ADDENDUM NO. 02

Wheatley Institute Third Floor Renovation

Project: Wheatley Institute – 3rd Floor Renovation

ADDENDUM NO. 2

RESPONSIBILITY MATRIX

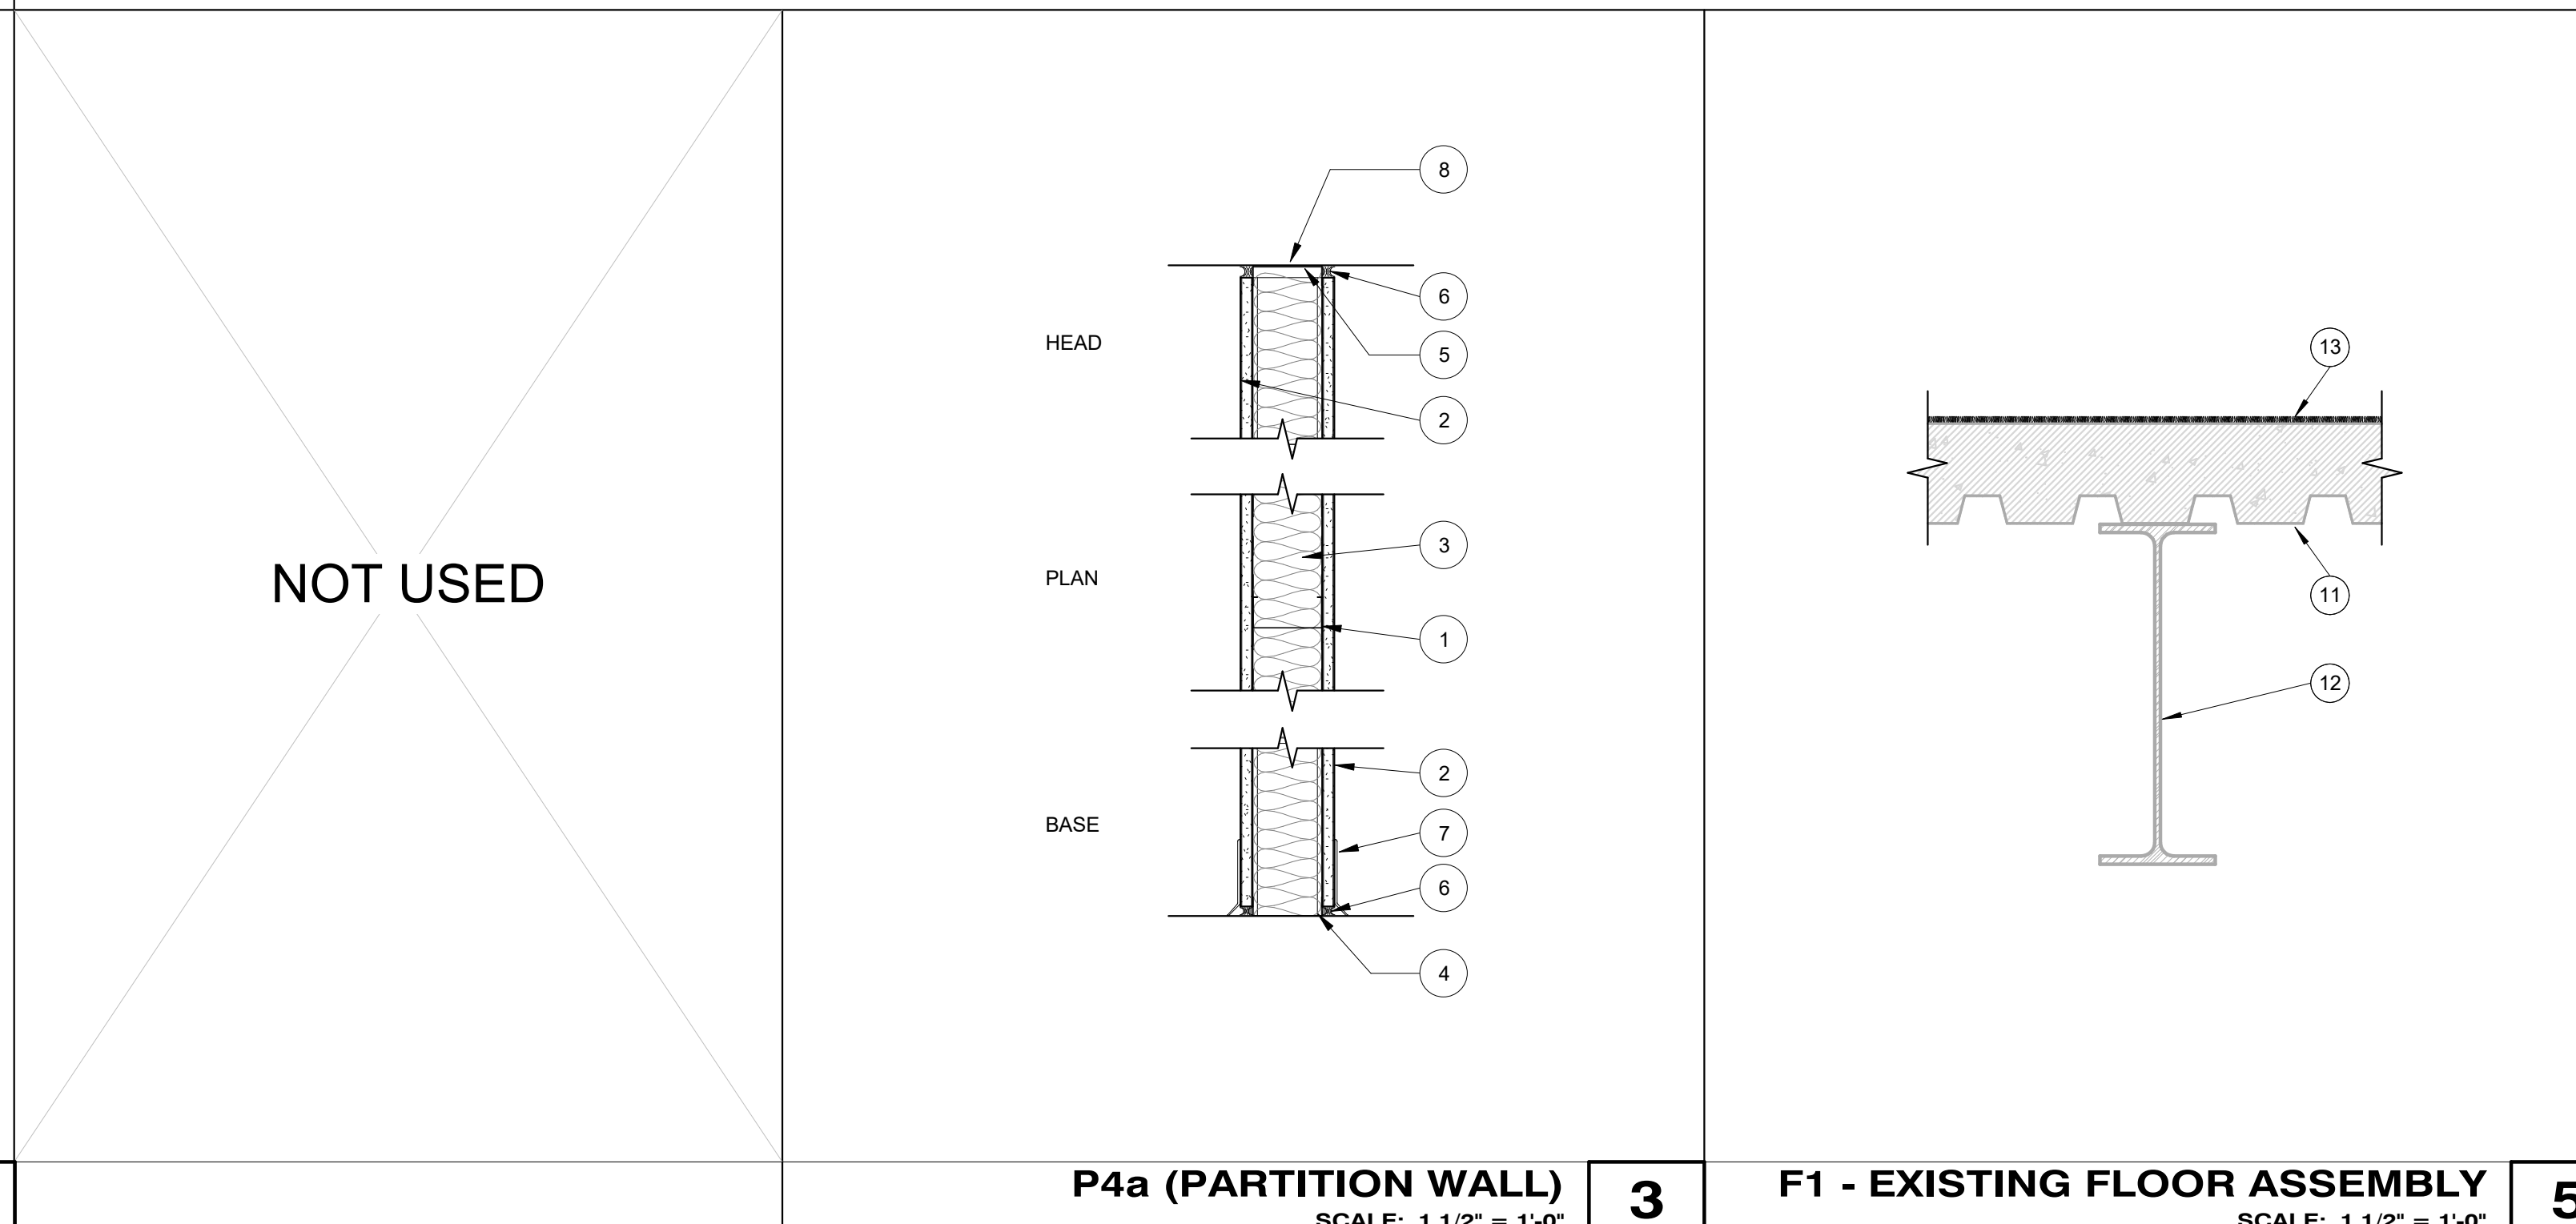
1. **Sheet G0.2**
 - REVISE: Responsibility Matrix for door hardware and signage.
2. **Sheet A1.1**
 - REVISE: Sheet keynote callout for door in hall 384 to show correct information.

12	A1.3 KN 10 and Elevation 5/A4.3: Is this signage by BYU or GC? If by GC please provide additional information (Specs).	All signage (room and dimensional) to be provided and installed by BYU. Responsibility Matrix has been revised to reflect this change and sheet as been reissued as part of this addendum.

M9243
A1.2

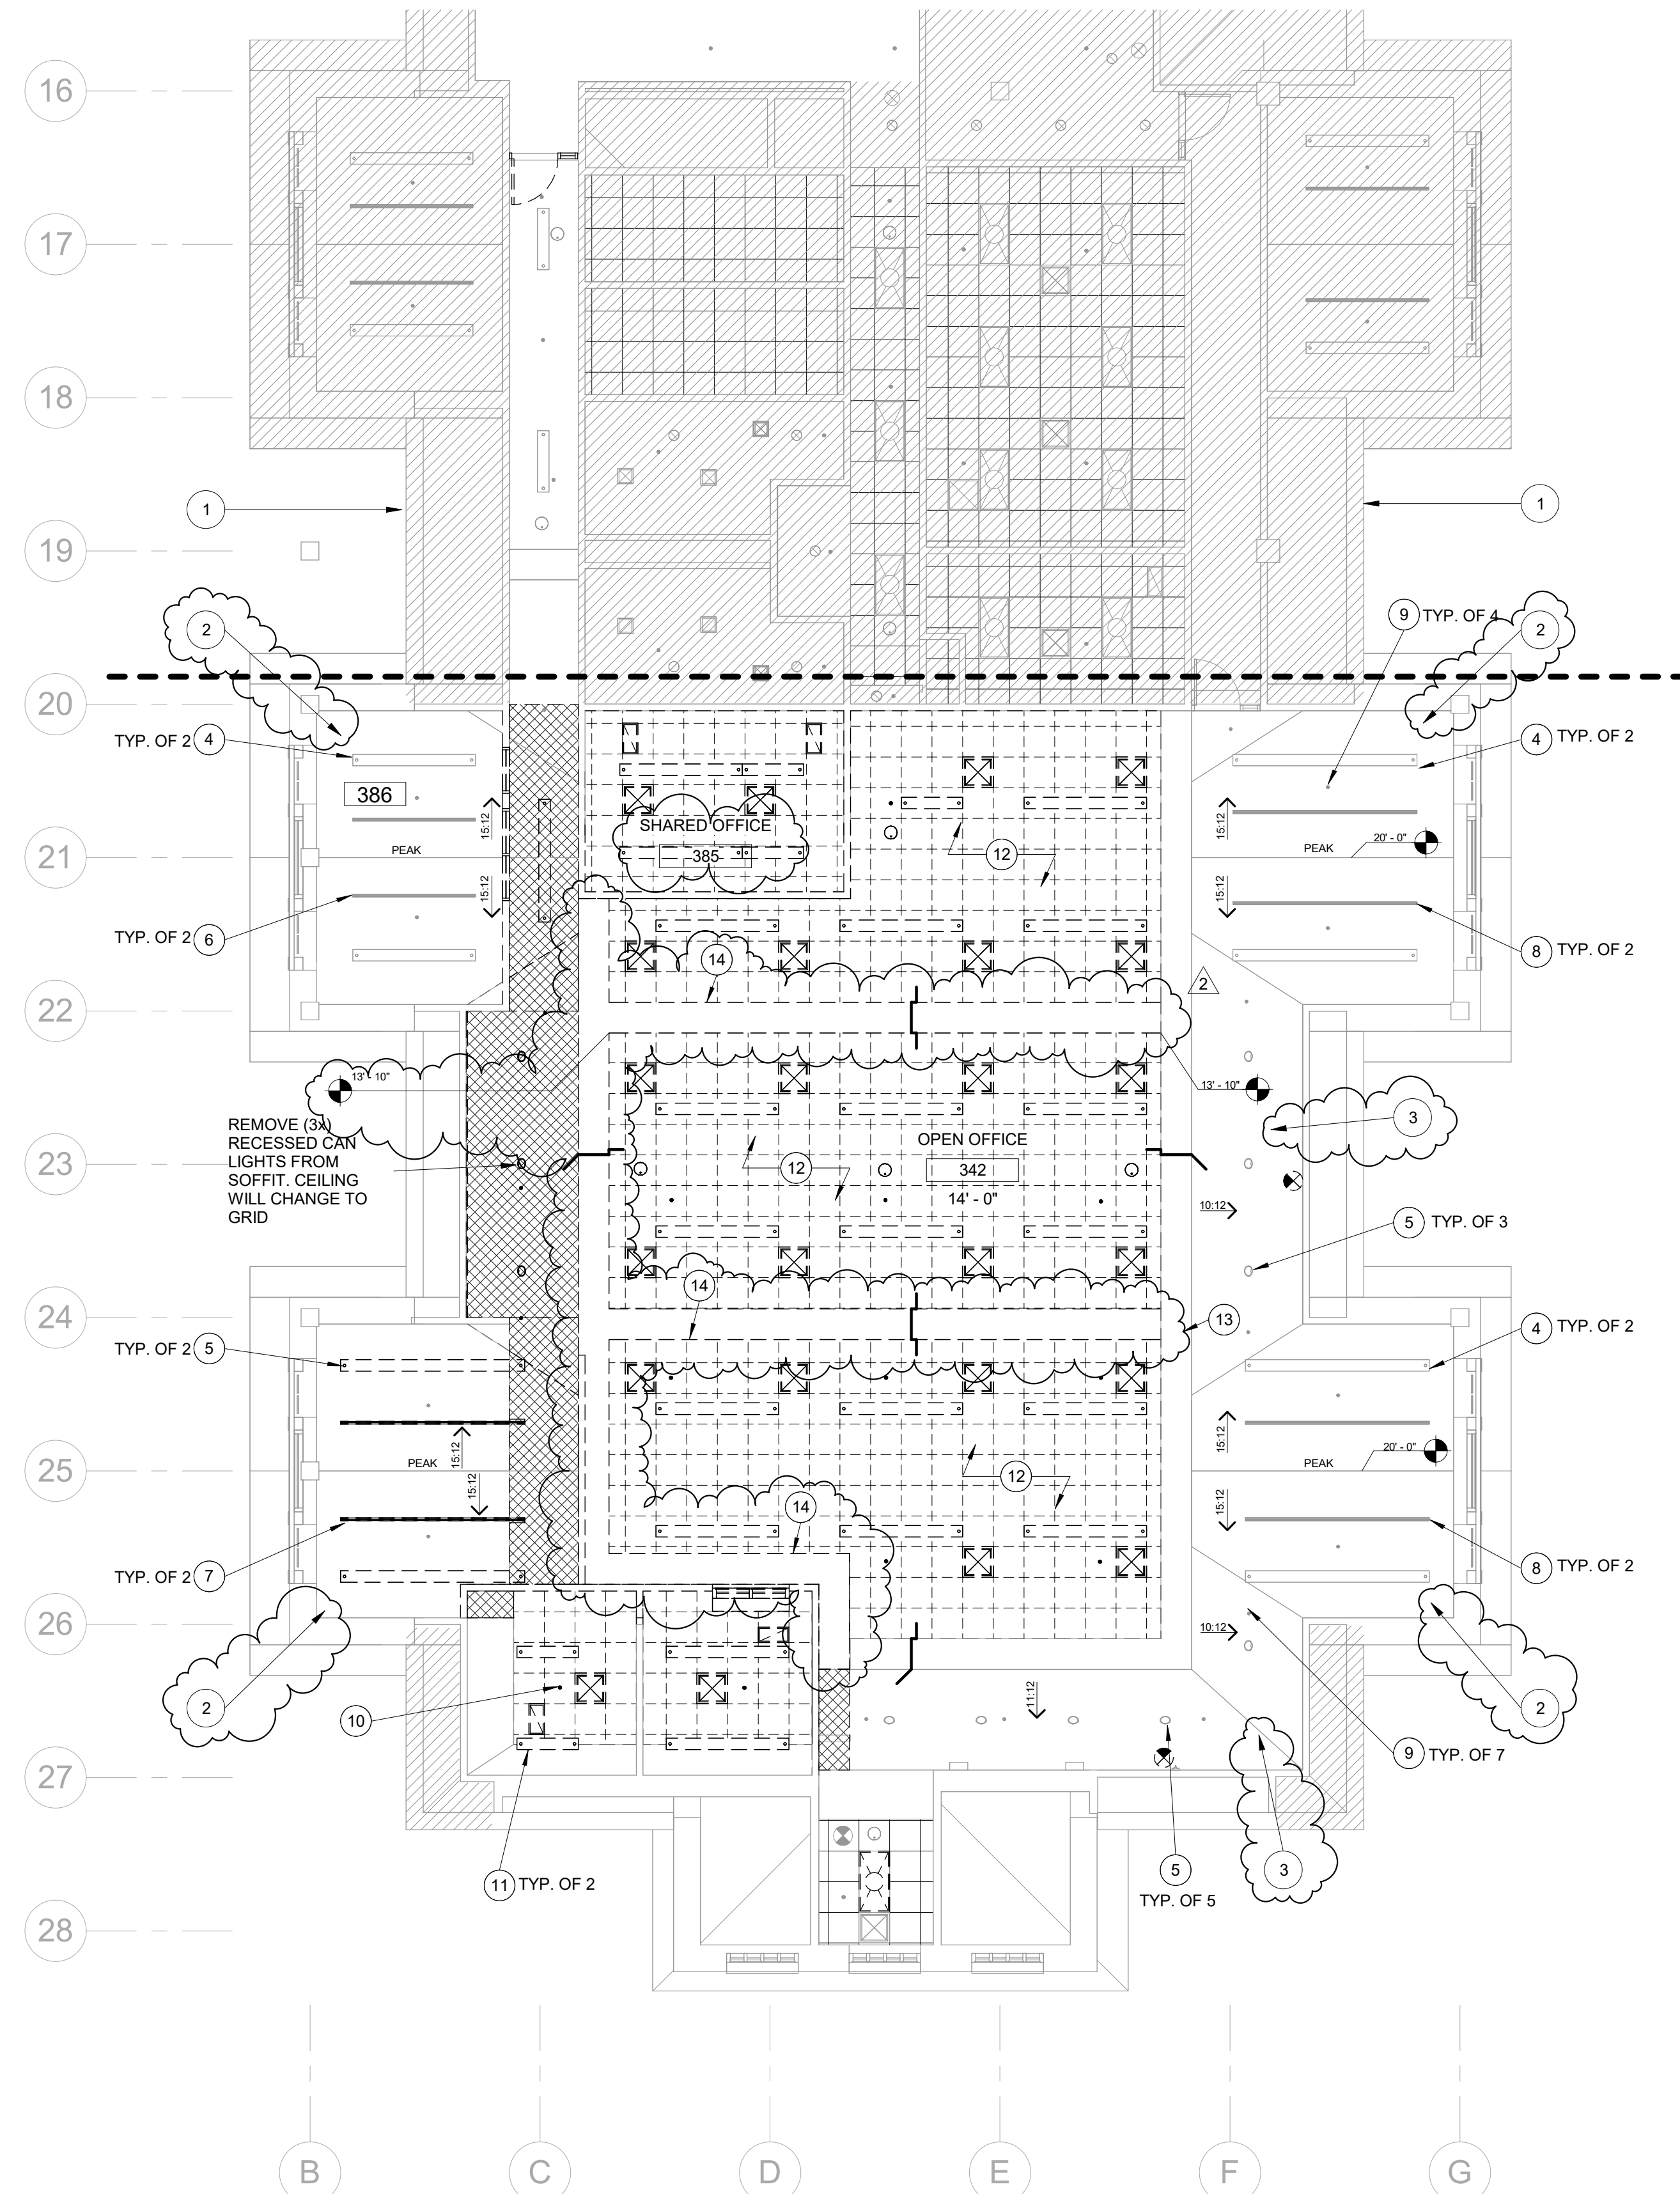
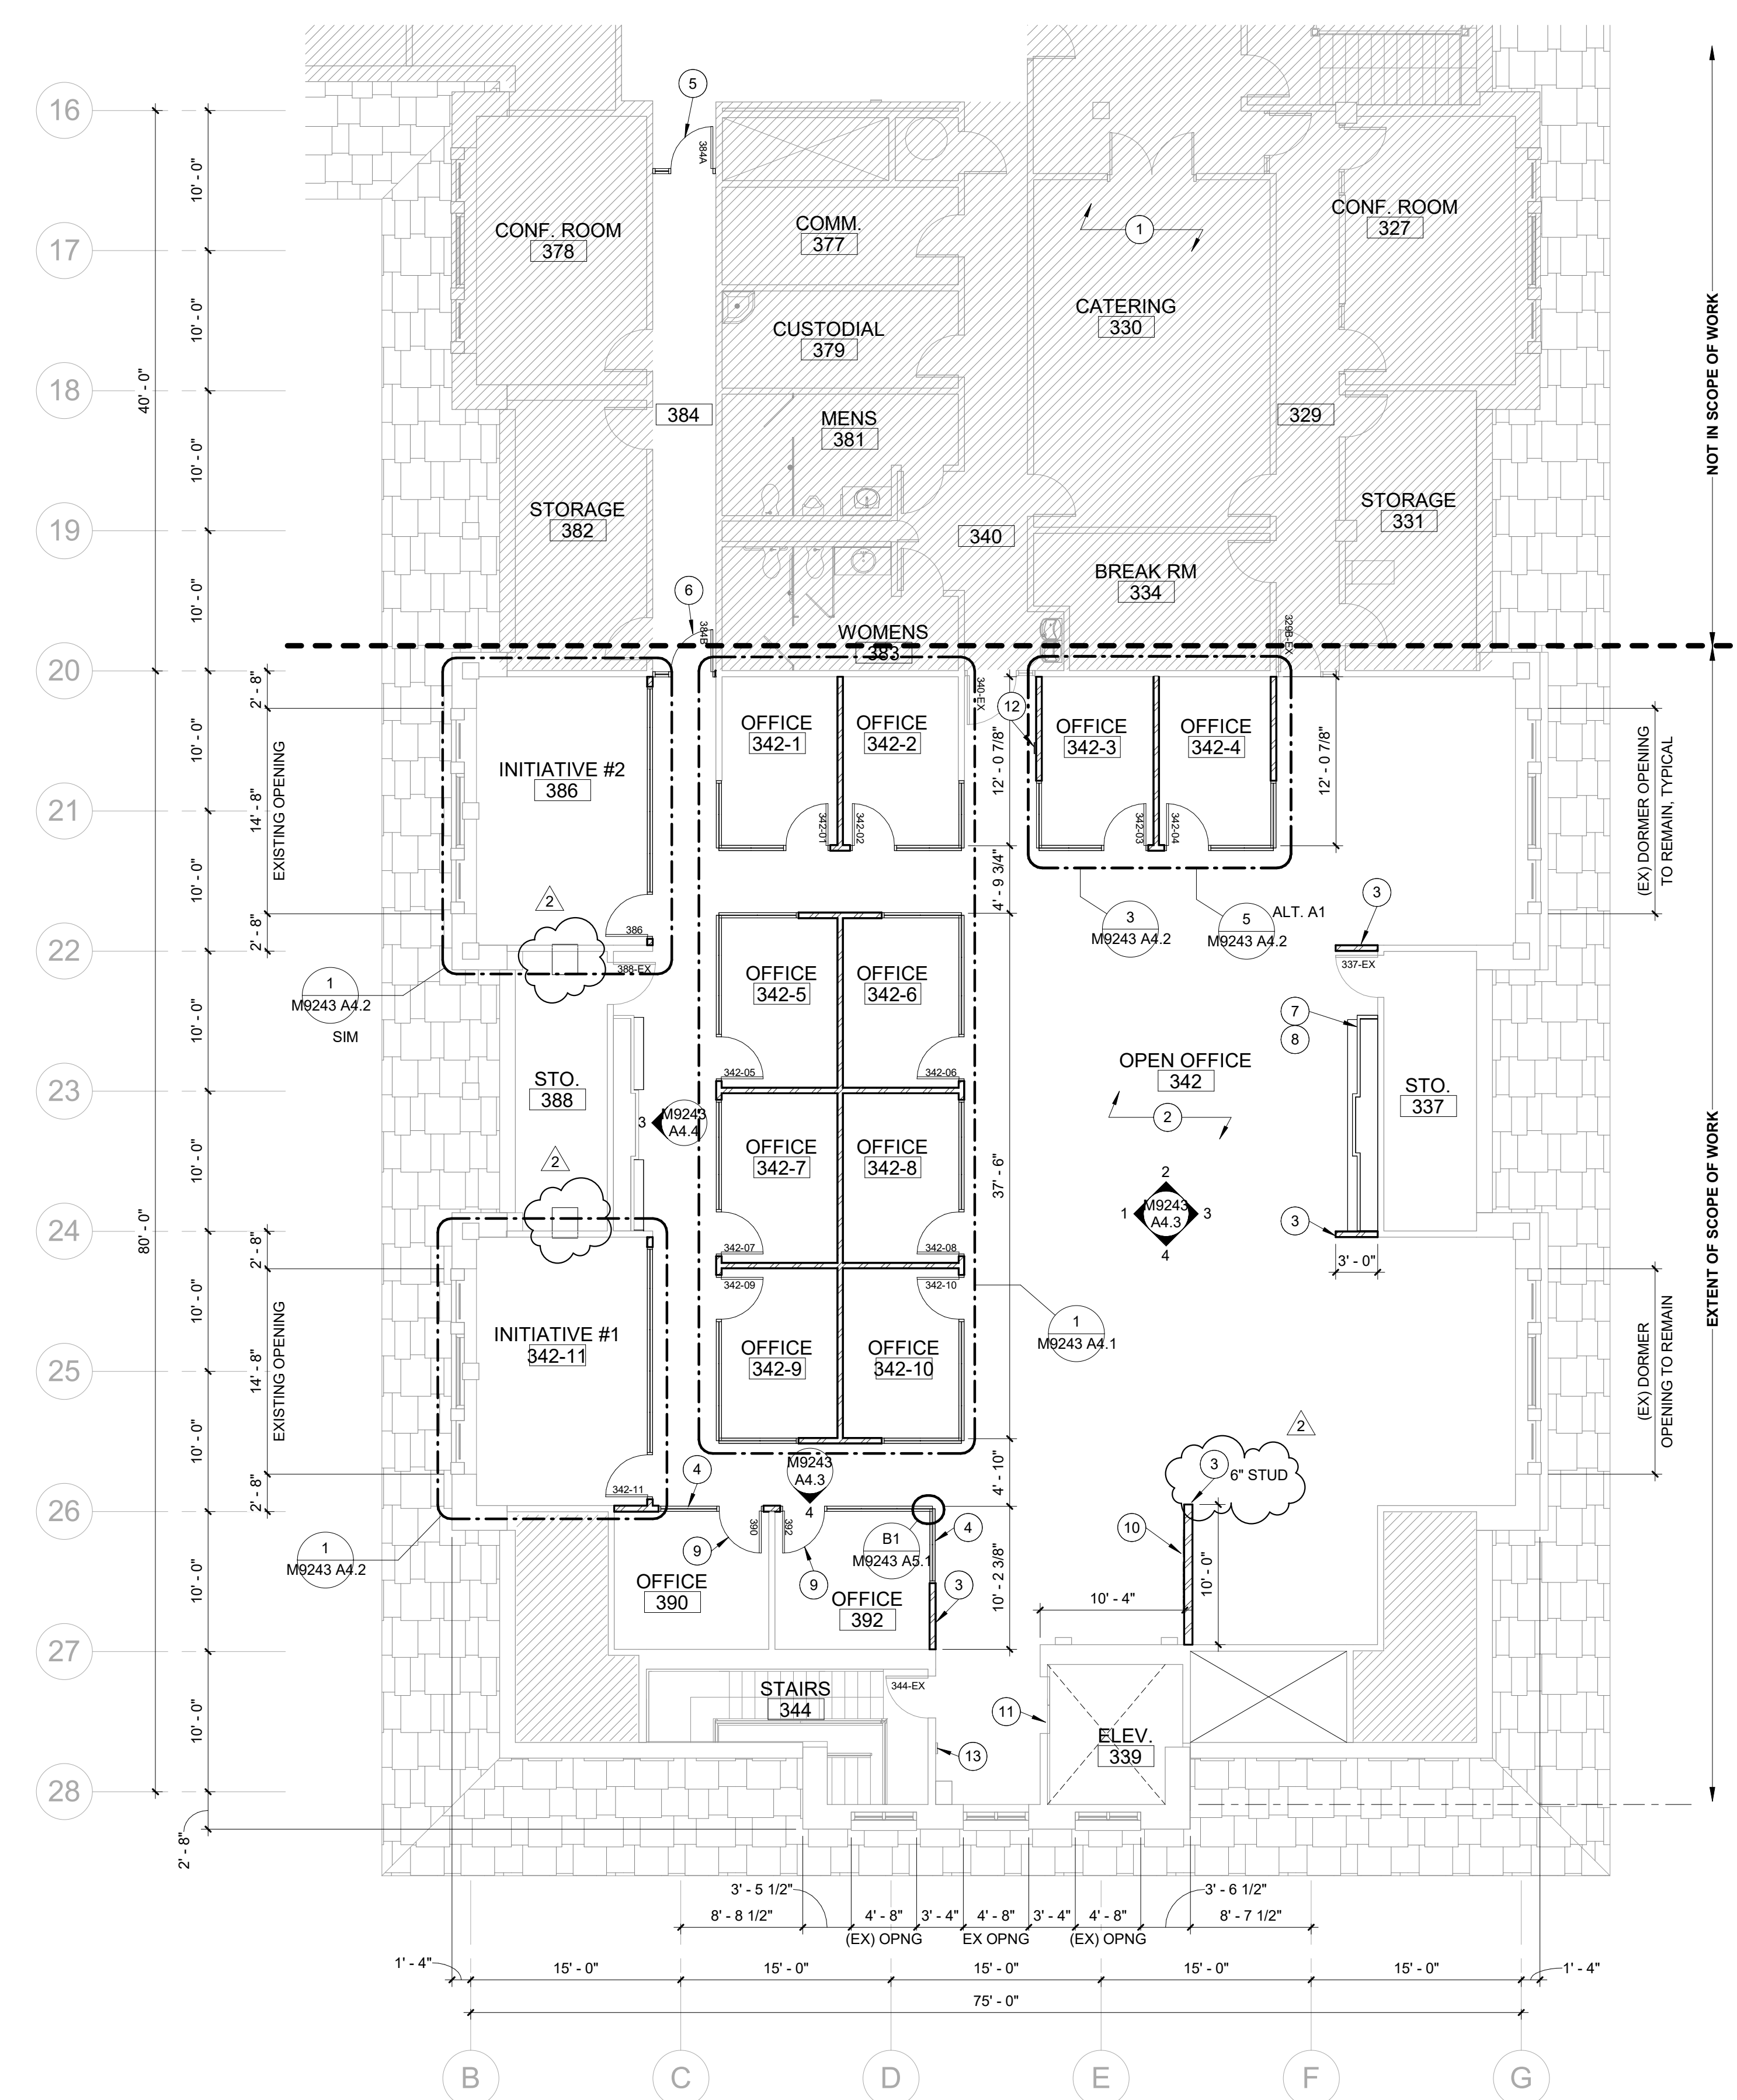
3. **Sheet A1.2**
 - ADD: Sheet keynote 14 & tag reference on plan to show portion of ceiling soffit to be removed as part of the demo scope. Elevation tags are shown for clarity.

- REVISE: Sheet keynotes 2 and 3 to show correct information.
4. **Sheet A1.3**
 - ADD: Location of new Fire/Smoke Damper in storage room 388 along with Return-Air-Grill in wall in Initiative Room 342-11.
